<b>DOCKETED</b>	
<b>Docket Number:</b>	23-AFC-03
<b>Project Title:</b>	Black Rock Geothermal Project (BRGP)
<b>TN #:</b>	253192
<b>Document Title:</b>	Black Rock Geothermal Project Data Request Response Set 1 (Revised Responses to Data Requests) Notice Letter to ICAPCD
<b>Description:</b>	N/A
<b>Filer:</b>	Lindsey Xayachack
<b>Organization:</b>	Jacobs
<b>Submitter Role:</b>	Applicant Consultant
<b>Submission Date:</b>	11/17/2023 1:30:52 PM
<b>Docketed Date:</b>	11/17/2023

**RE: Notification for Permit Application to Construct for the Black Rock Geothermal Project, Imperial County, California**

## Attachment A: Revised BRGP Well Layout

**Figure 1-4R**  
**Project Location**  
**Black Rock Geothermal Project**  
Imperial County, California

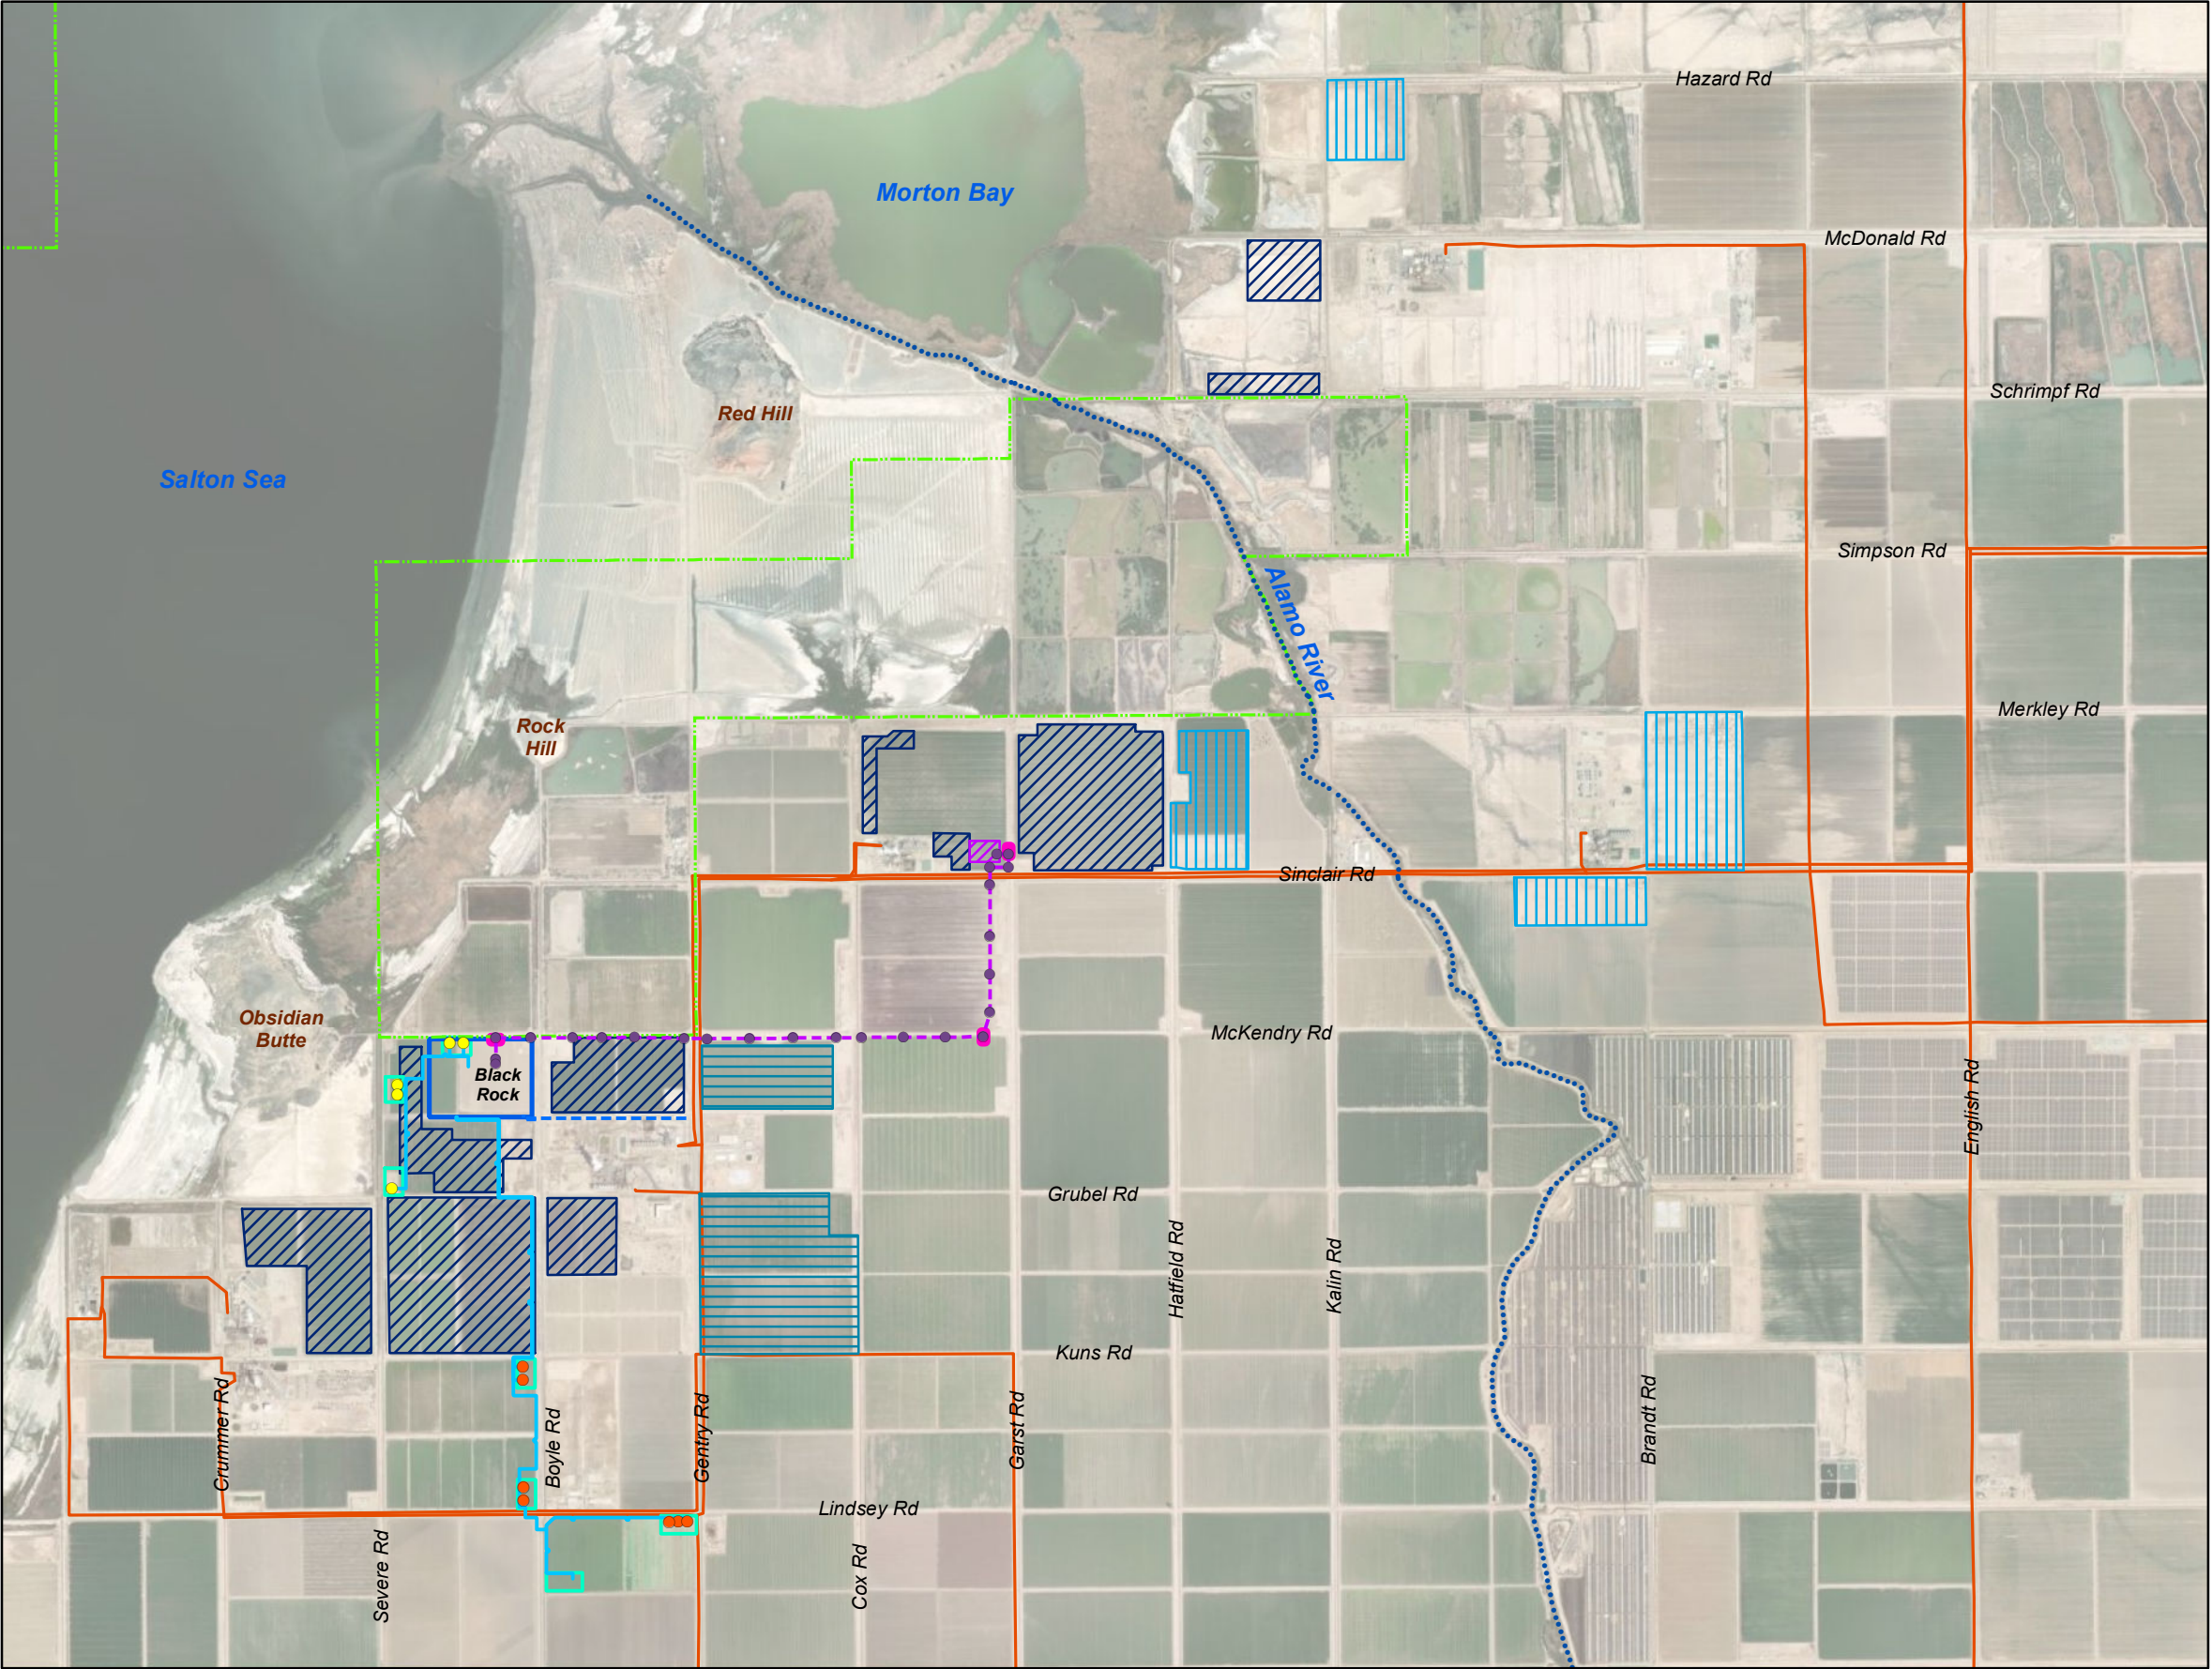
Recent updates have been made to the BRGP design which were not able to be incorporated into the revised analyses submitted on November 10, 2023. Specifically, the location and orientation of the offsite wells and associated well pads have shifted. A figure showing the latest BRGP well design layout is included as Attachment A.

These minor layout changes only pertain to offsite emission sources with limited operation and the number of offsite wells has remained the same. Therefore, the emission estimates, air quality impact analyses, and health risk assessment modeling submitted to ICAPCD on November 10<sup>th</sup> are considered to be conservative as well as representative of the updated BRGP design. For these reasons, the Applicant will not be submitting revised analyses for the updated BRGP design.
